**SUBJECT: AP1000 COL Standard Technical Report Submittal of APP-GW-GLR-022, Revision 1
(Technical Report Number 8)**

APP-GW-GLR-022, Revision 1

“AP1000 Leak-Before-Break Evaluation of As-Designed Piping”

Technical Report Number 8

Figure 2-8

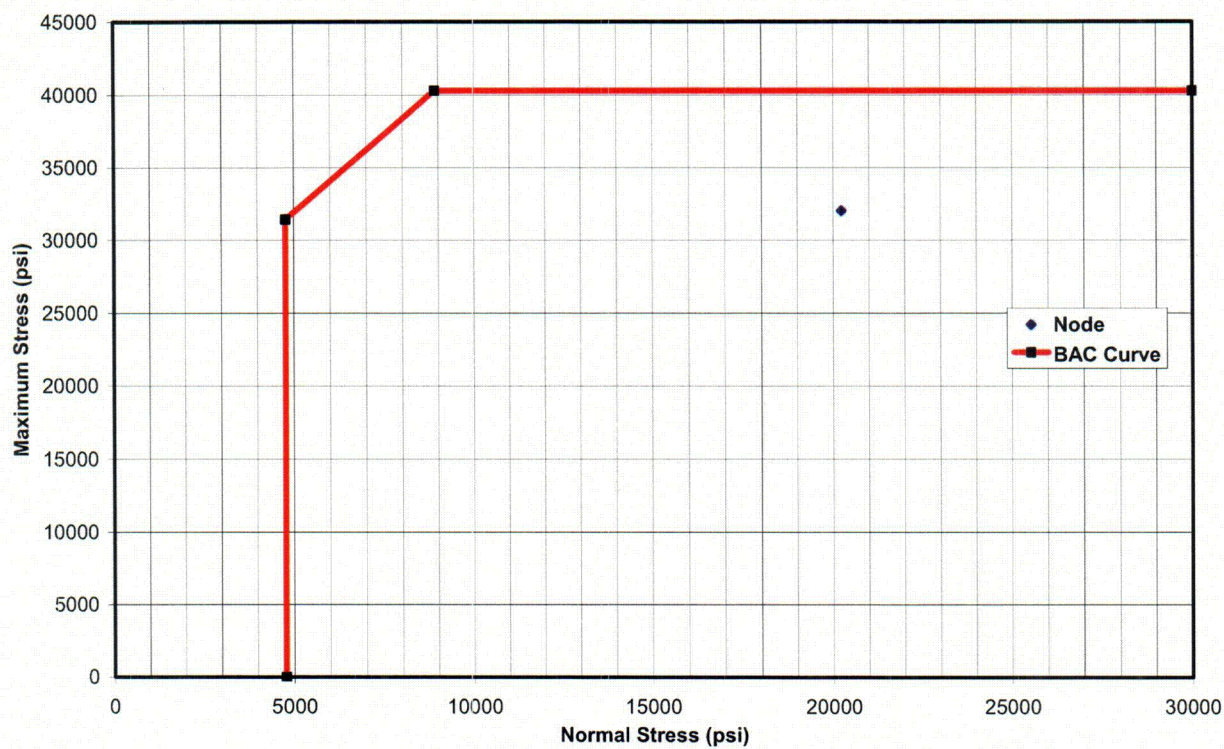
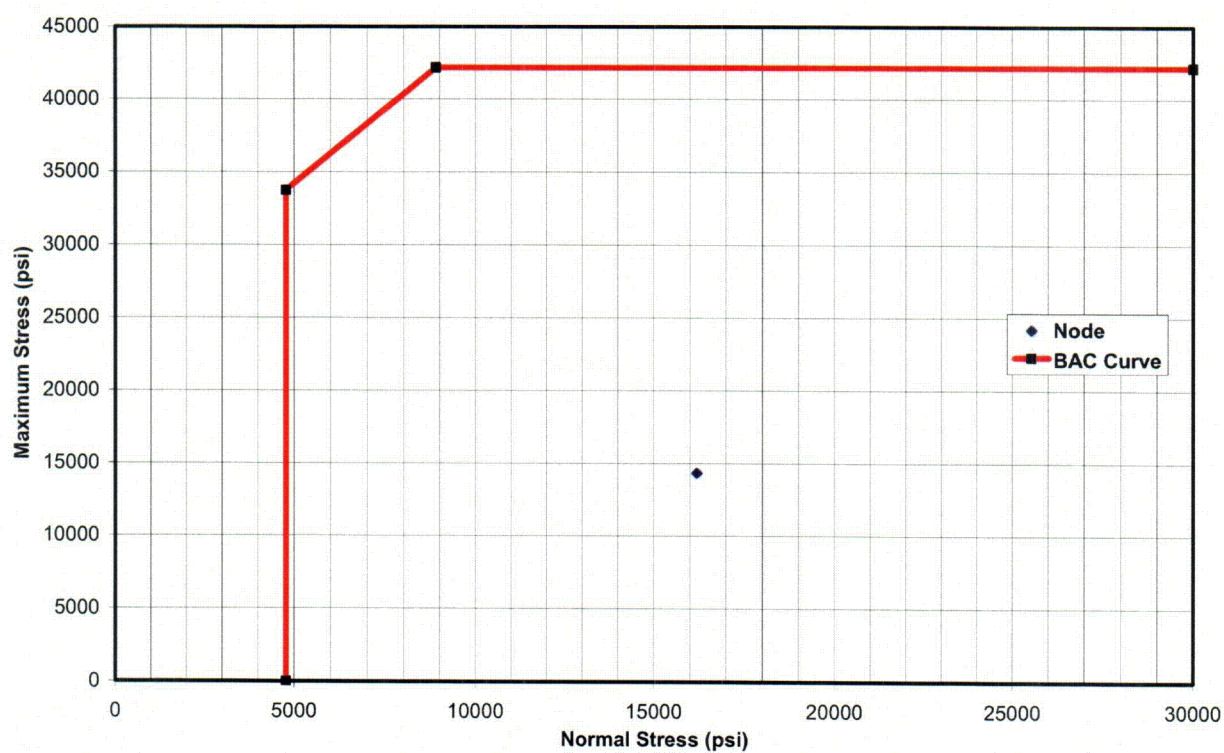
This report revises Technical Report 8, Revision 0, which was previously submitted in the Referenced Letter. The revisions have been listed in a table of revisions in the report and are identified by bar marks in the margins of affected pages. The Leak-Before-Break curves and stress analyses for the pressurizer surge line, Figures 2-8 and 2-9, have been completed and added to the document. The list of references has been updated.

Figure 2-10

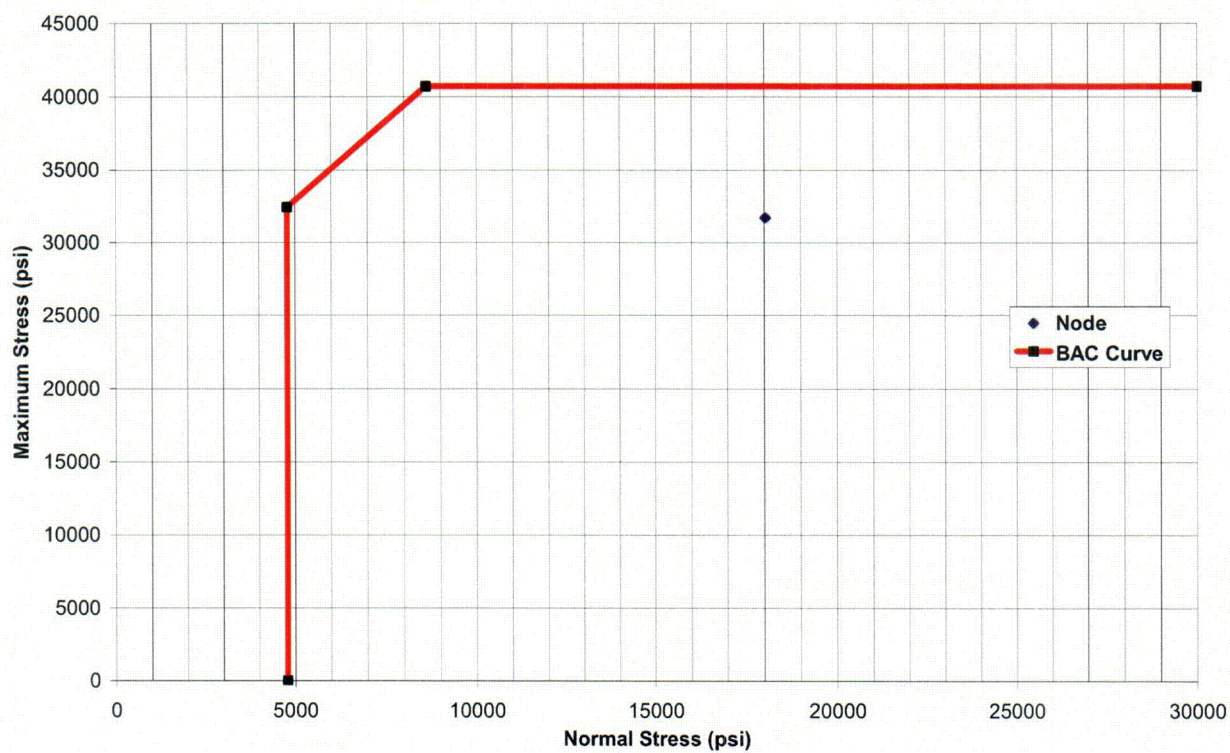
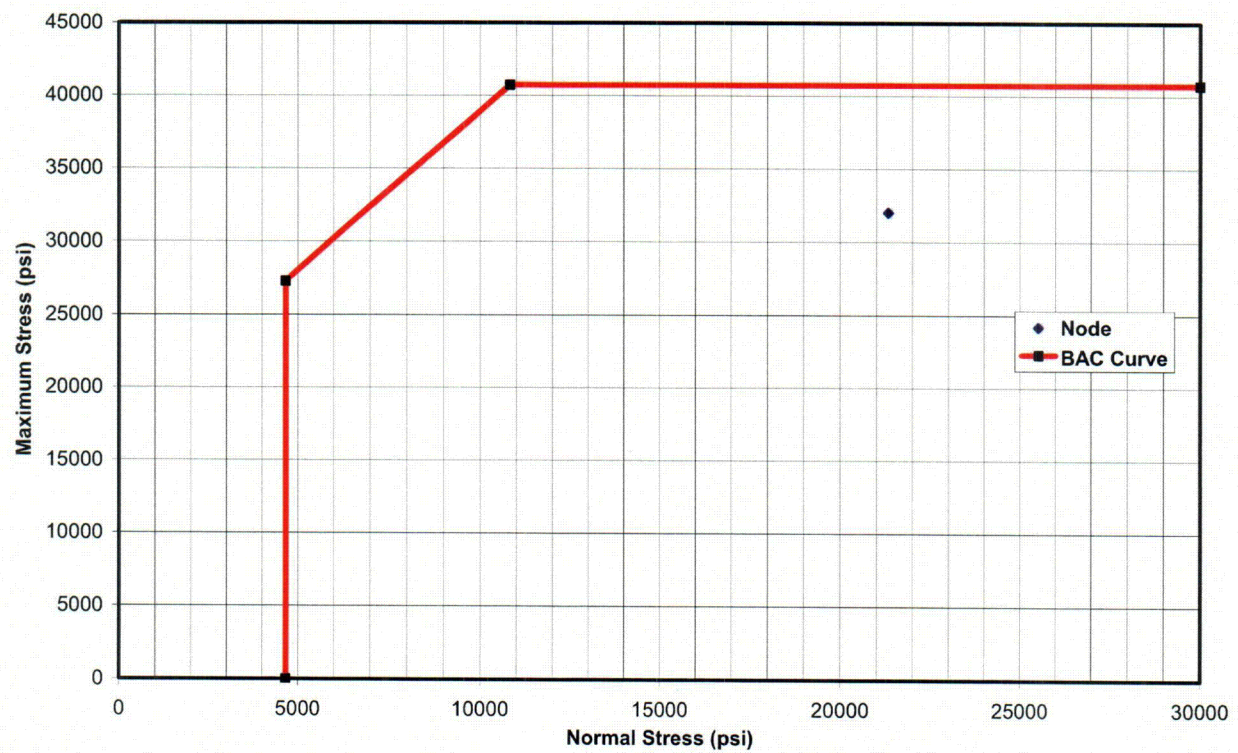
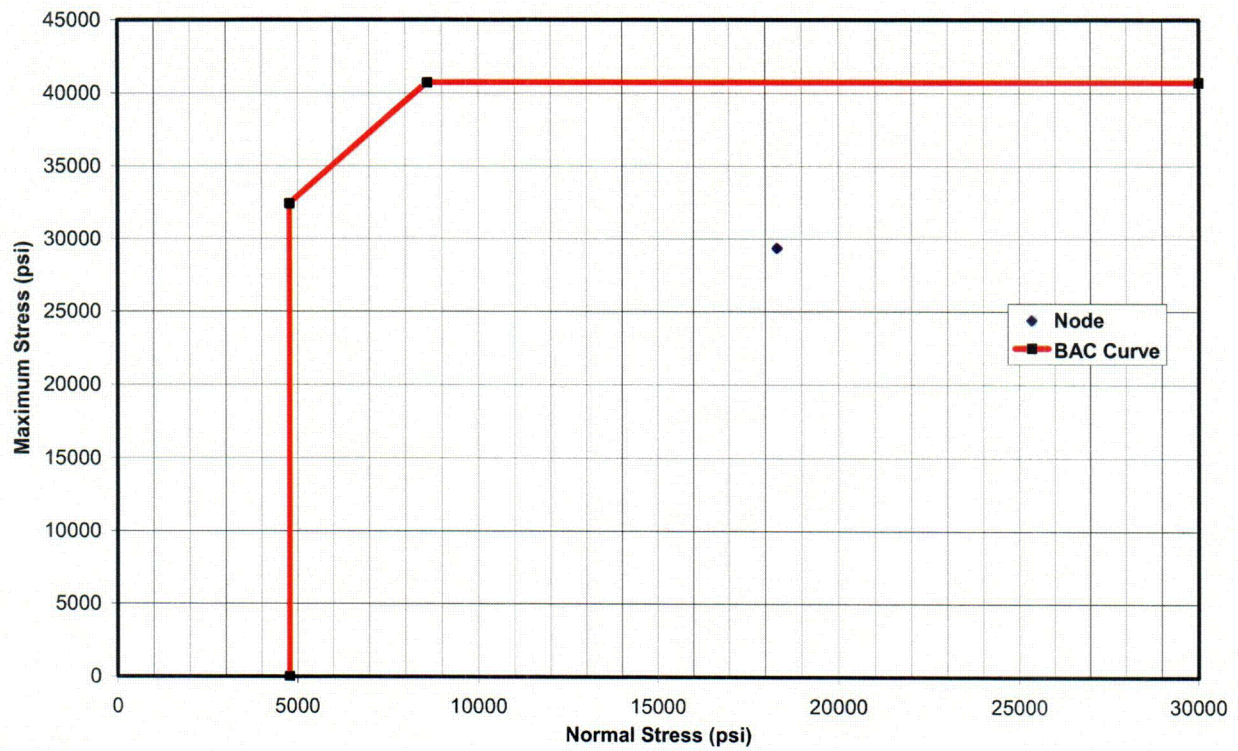
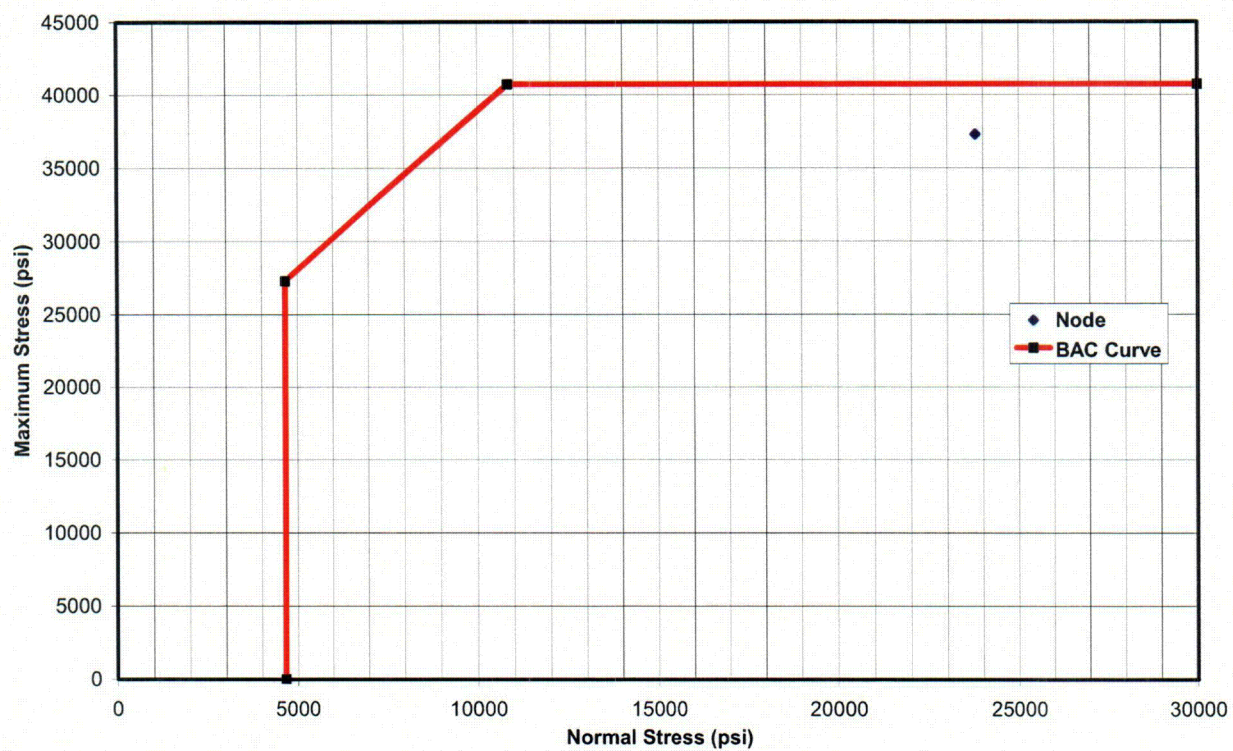
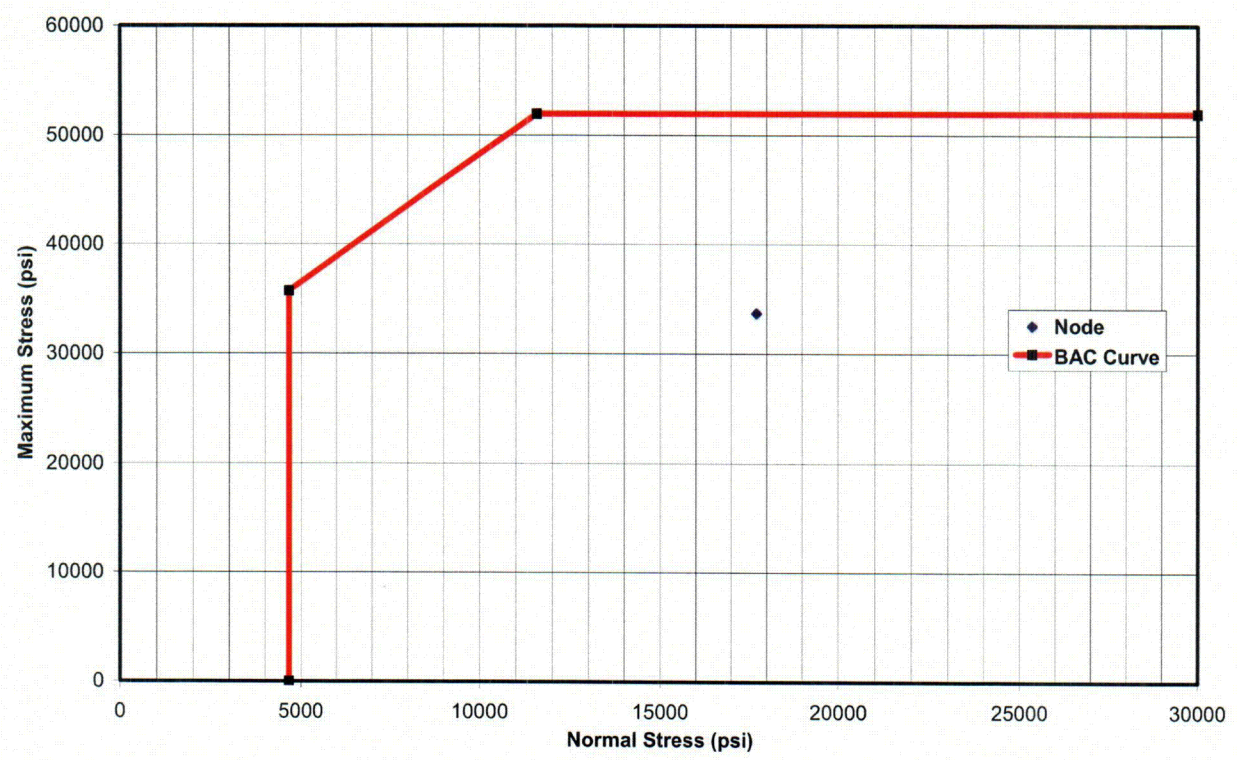
The critical points for five of the curves, Figures 2-10 through 2-14, for the ADS-4 line have been updated. The critical points for these curves remain under the curve. The need for the change was discovered during the evaluation of the pressurizer surge line. The issue that resulted in the changes has been entered into our corrective action program and we have verified that the critical point locations in the remaining curves are not impacted.

Figure 4-1

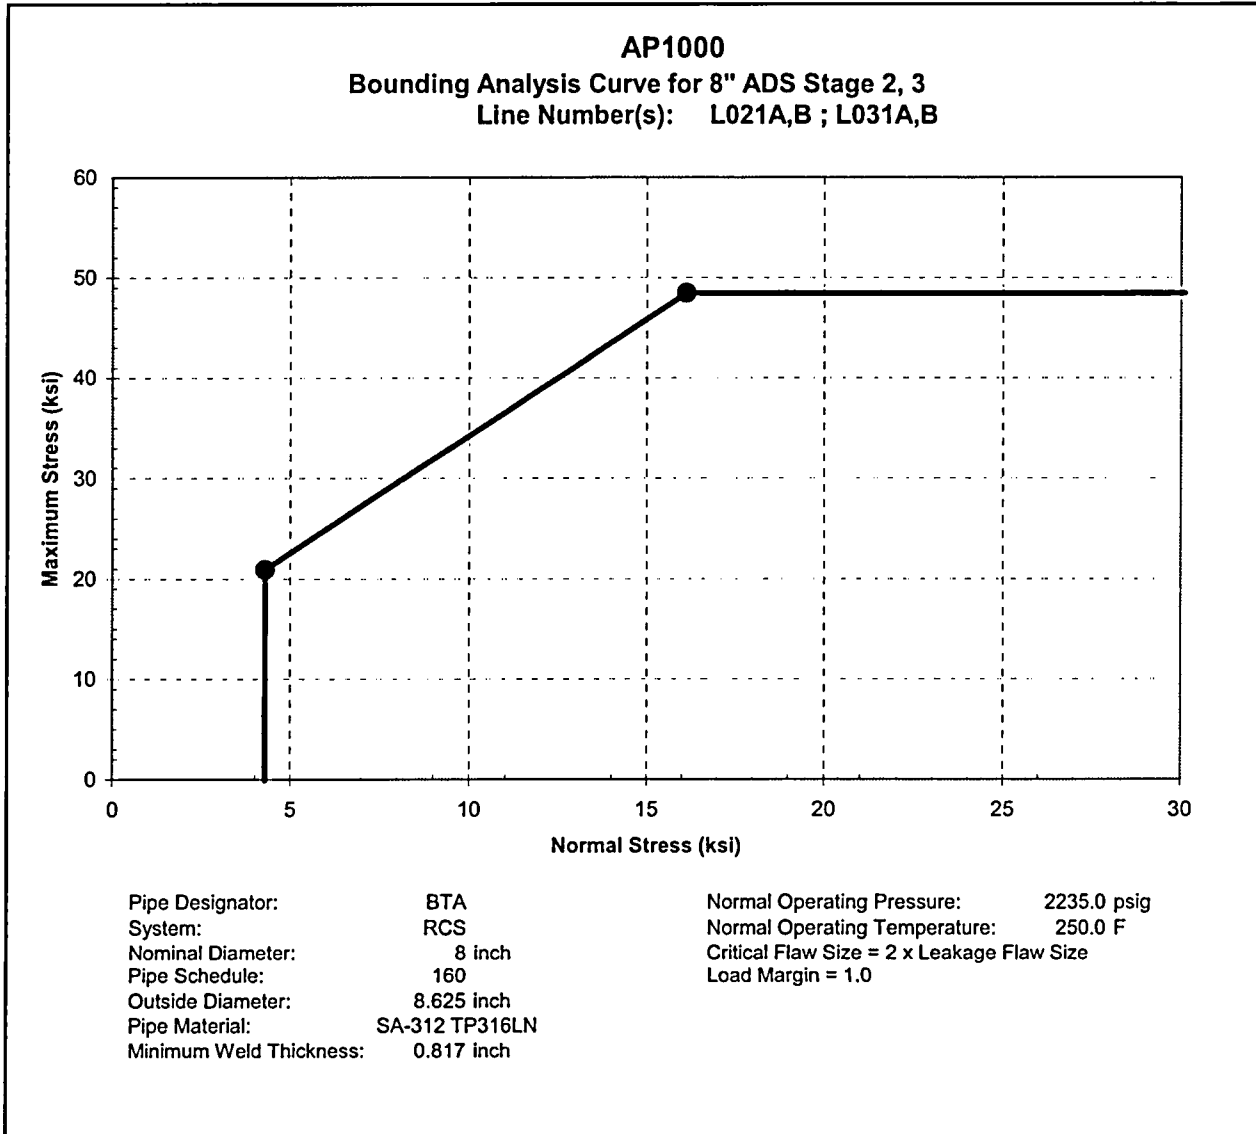
Figure 3B-22 is added and used for evaluation of the 8" ADS Stage 2-3 instead of Figure 3B-16 in Appendix 3B of the DCD. The bounding analysis curves for the 8" ADS stage 2, 3 pipe lines in the DCD are supplemented in this report to reflect the pipe temperature in the cold trap region (maximum temperature of 250 degrees F).

Figure 4-2

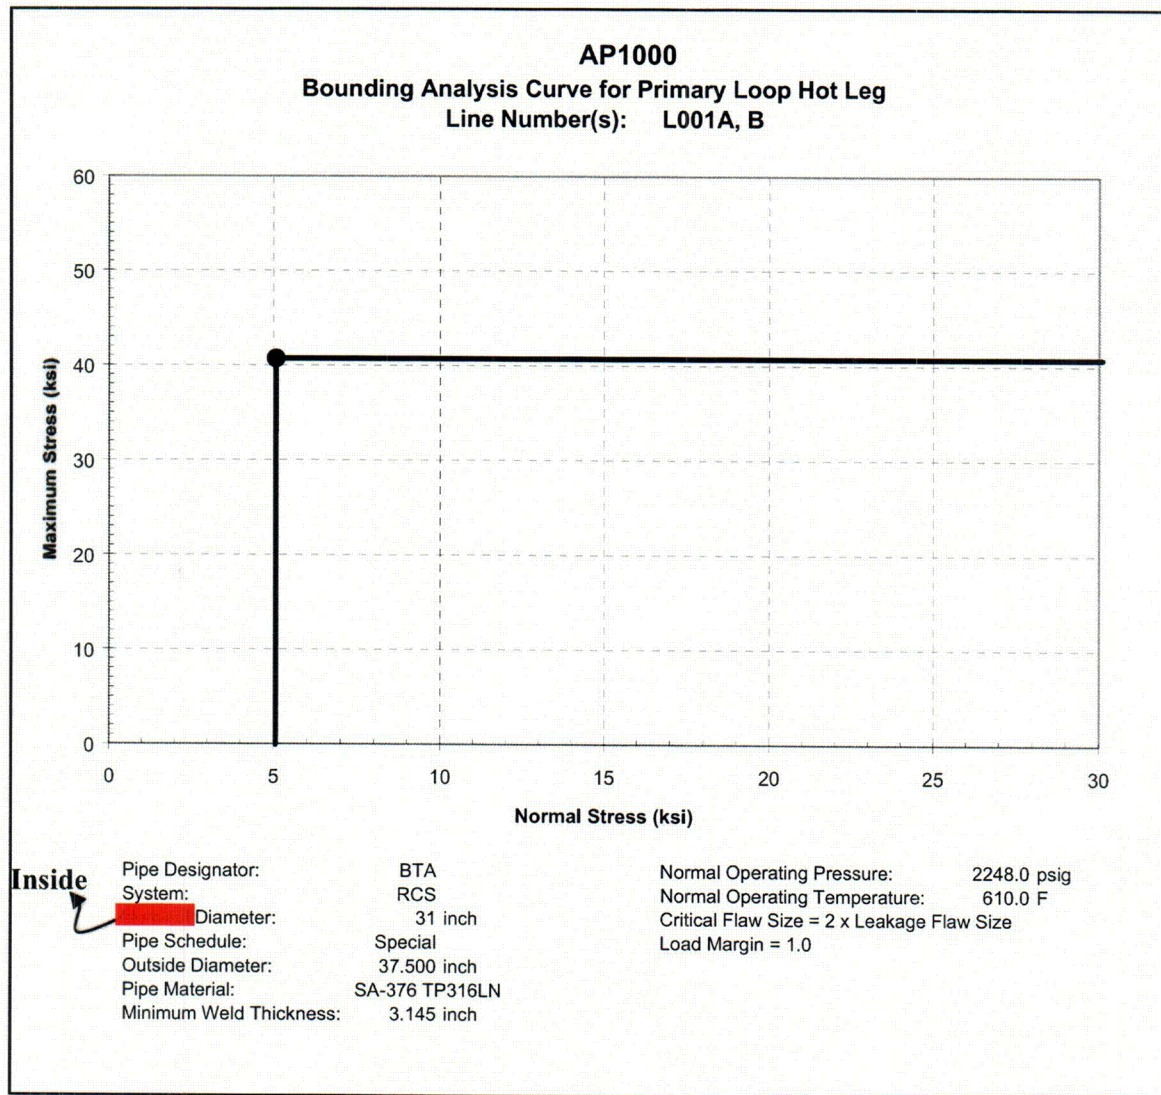
Figure 3B-2 is changed so that the 31" diameter is the inside diameter, not a nominal diameter.

Figure 4-3

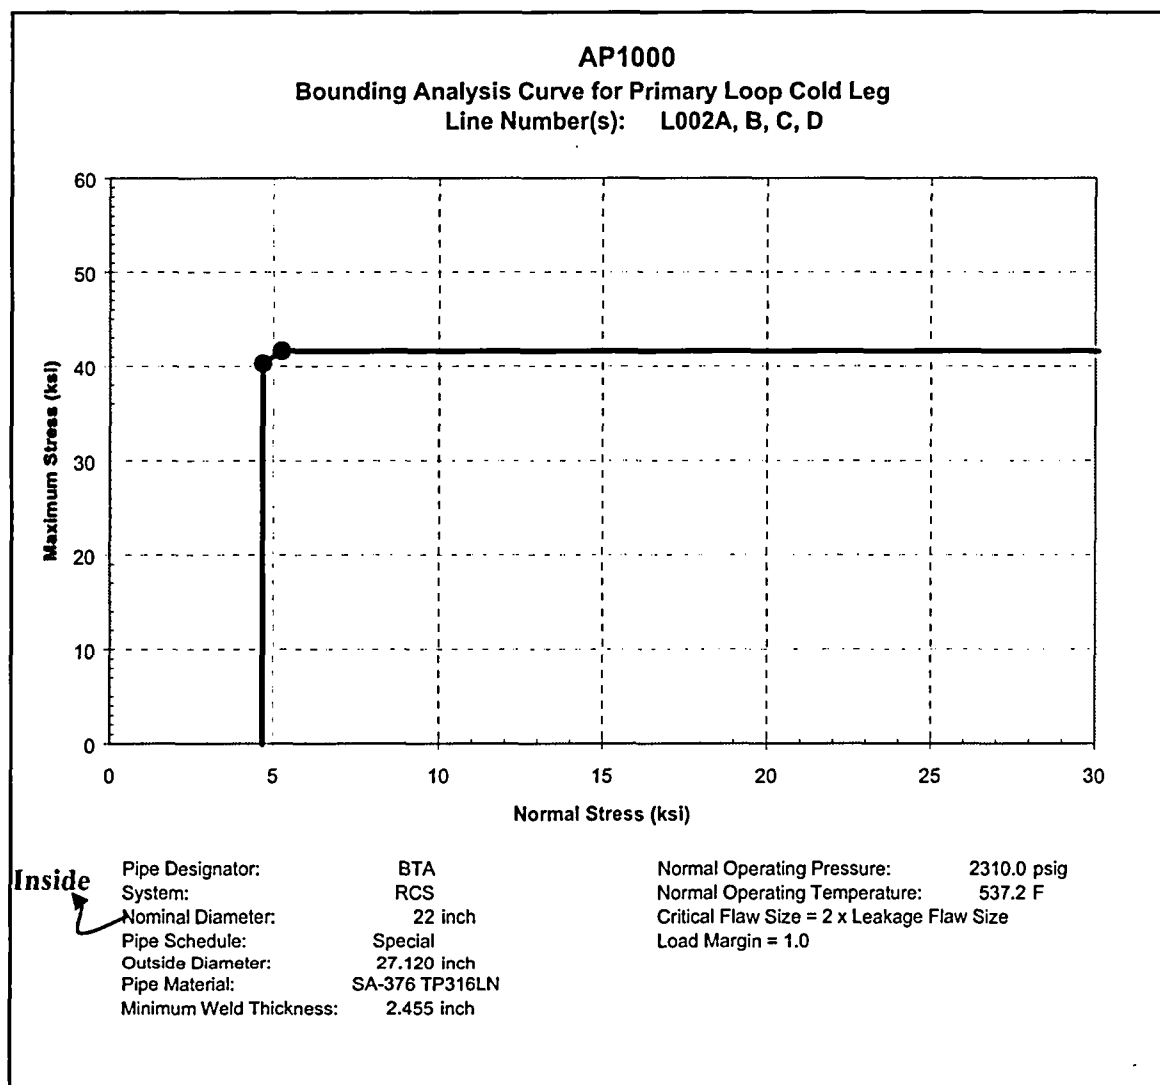
Figure 3B-3 is changed so that the 22" diameter is the inside diameter, not a nominal diameter.
